RE: Townhomes for Greg Lobberegt
Grading and Drainage Plan
Engineer's Stamp Date 2-6-2017 (File: H22D026)

**Re: Townhouses for Greg Lobberegt
2400 Marie Park NE
Traffic Circulation Layout
Architect's Stamp dated 11-22-16 (H22-D026)**

Project Title: Townhouses for Greg Lobberegt Building Permit #: _____ City Drainage #: H22D026
 DRB#: PENDING EPC#: PENDING Work Order#: _____
 Legal Description: TRACT A-2-A-1 BLOCK 13, BRENTWOOD HILLS SUBD.
 City Address: 2400 MARIE PARK DR. N.E.

1 TRAFFIC CONTROL LAYOUT
Scale 1" = 20'-0"

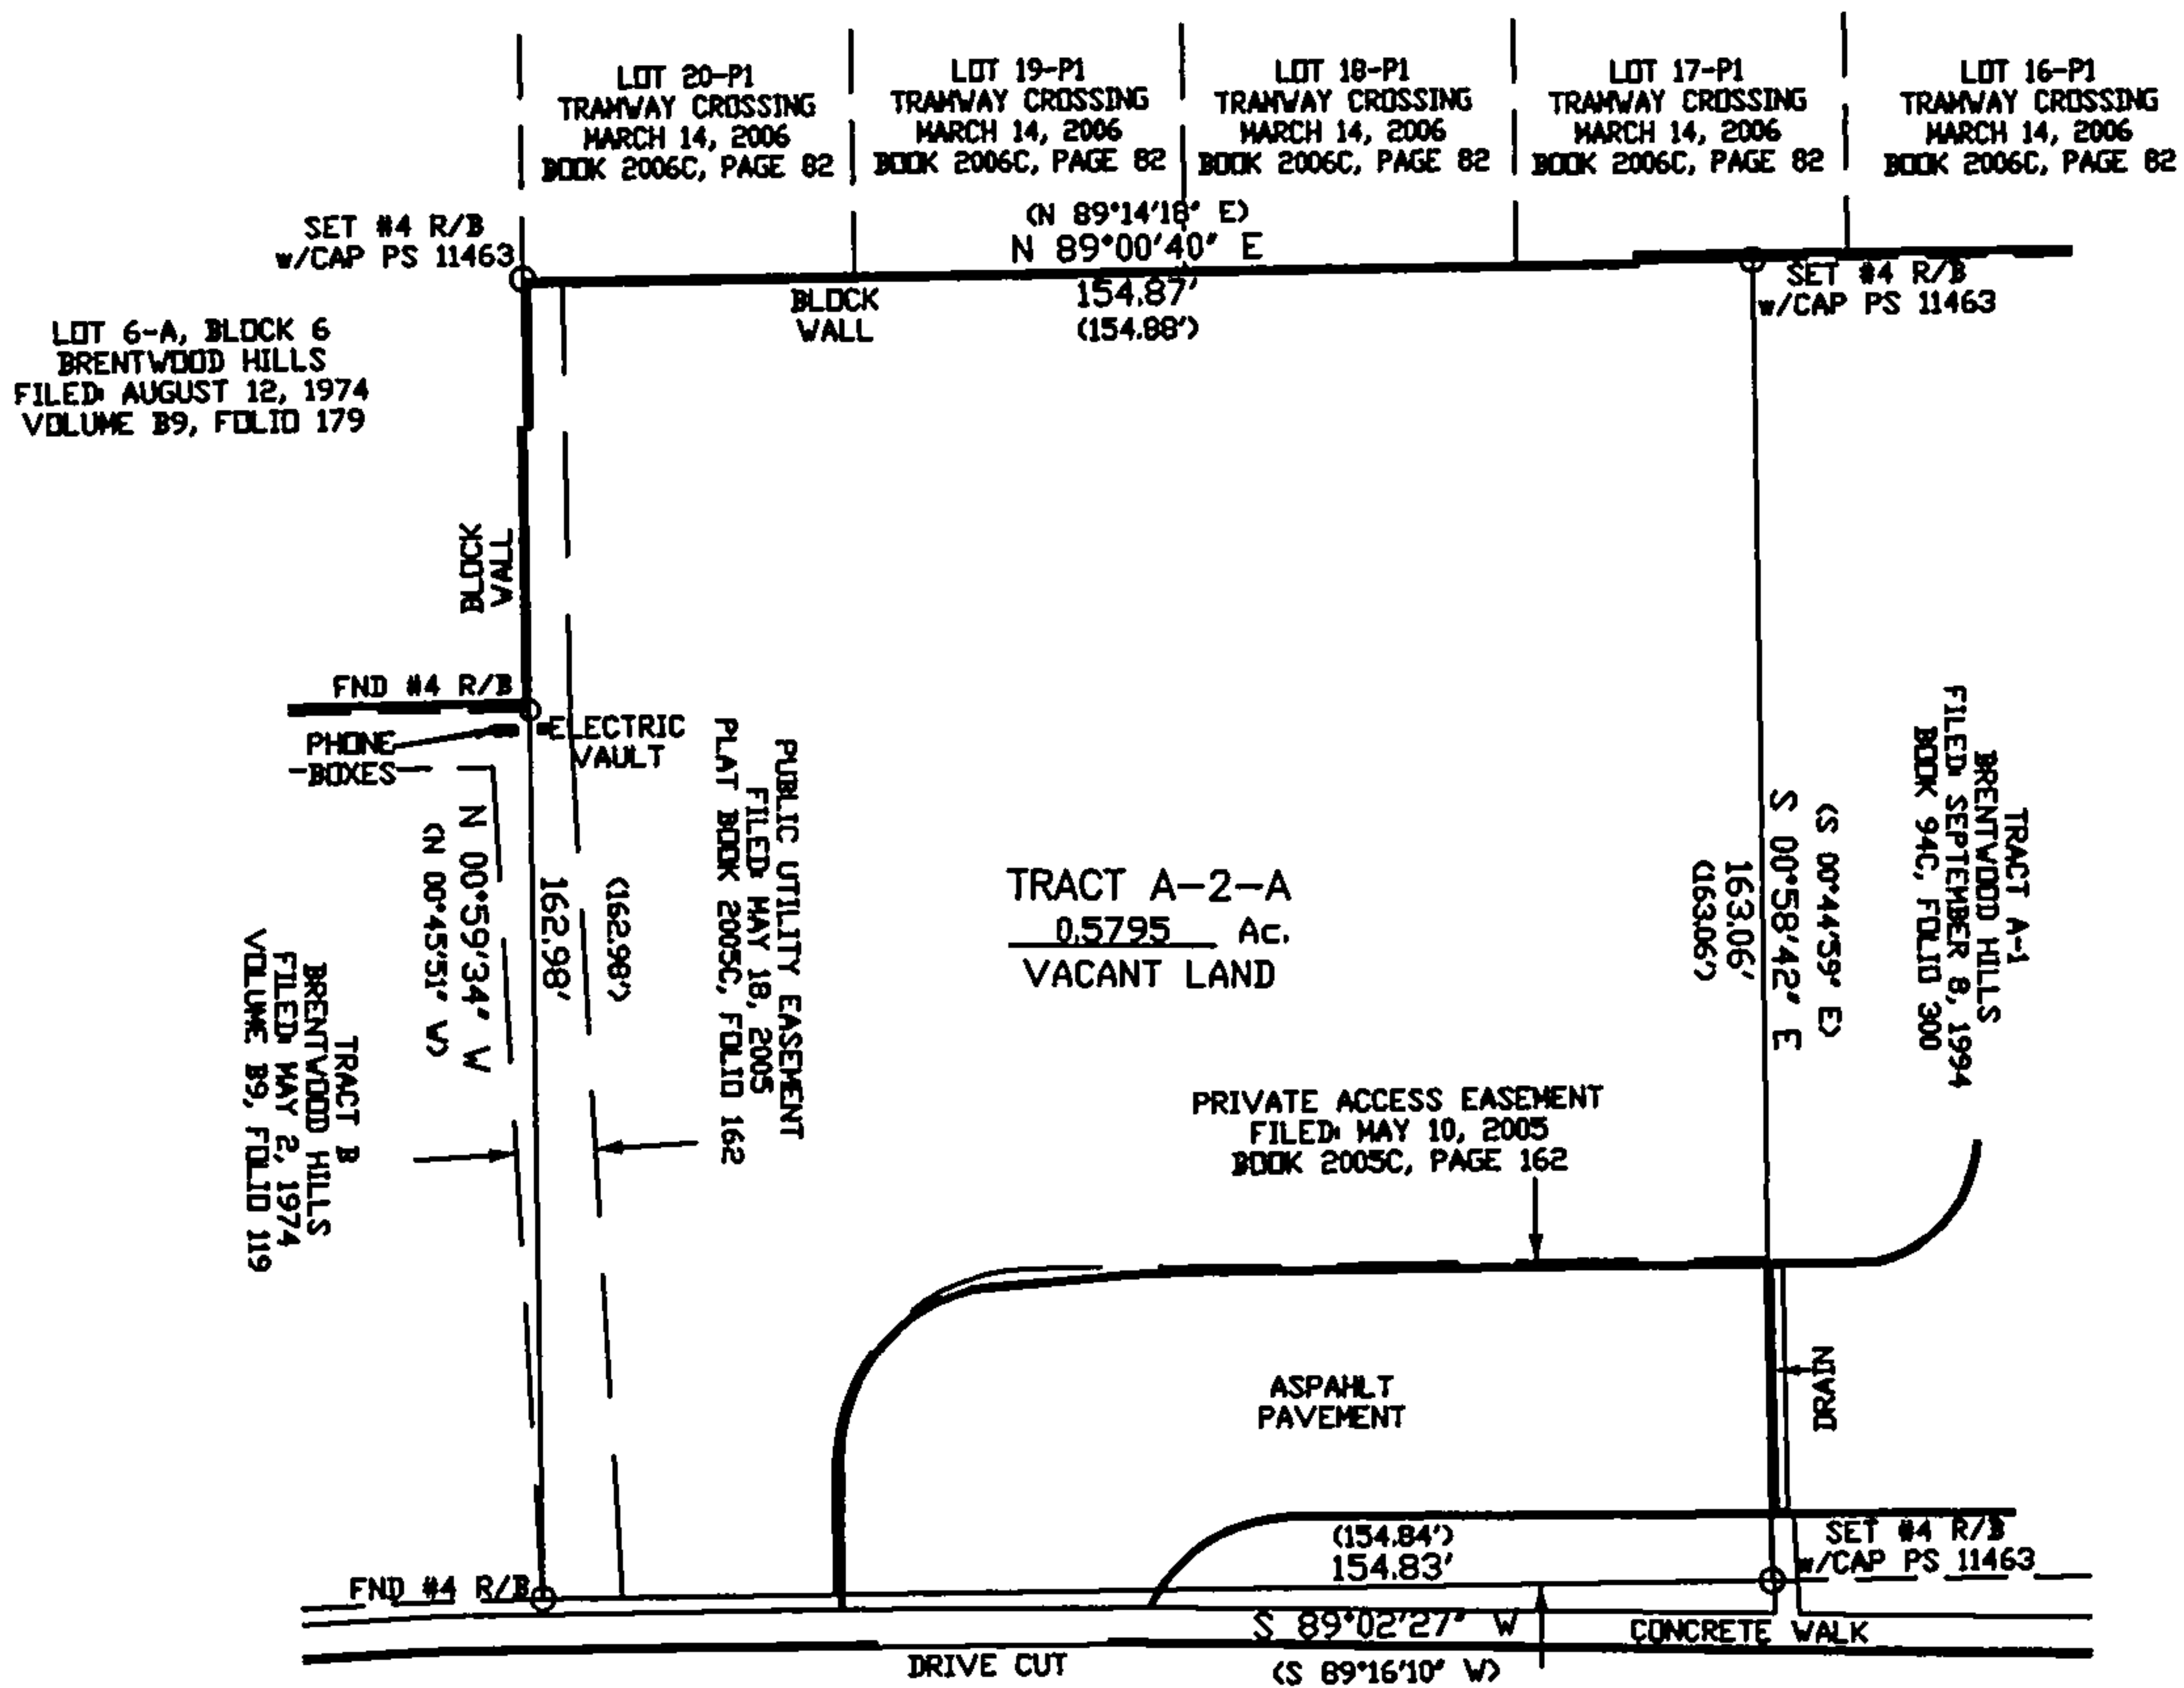
I have a few minor comment on the TCL for 2400 Marie Park.

1. The Truncated domes on the second sheet need to be 2 feet wide and should have a note that they will be "Cast-In-Place replaceable".
2. Please add directional arrows at the exit and at decision point along the long road.
3. We will need fire's approval.

This can be addressed by redline if you would like to come in and make the changes.
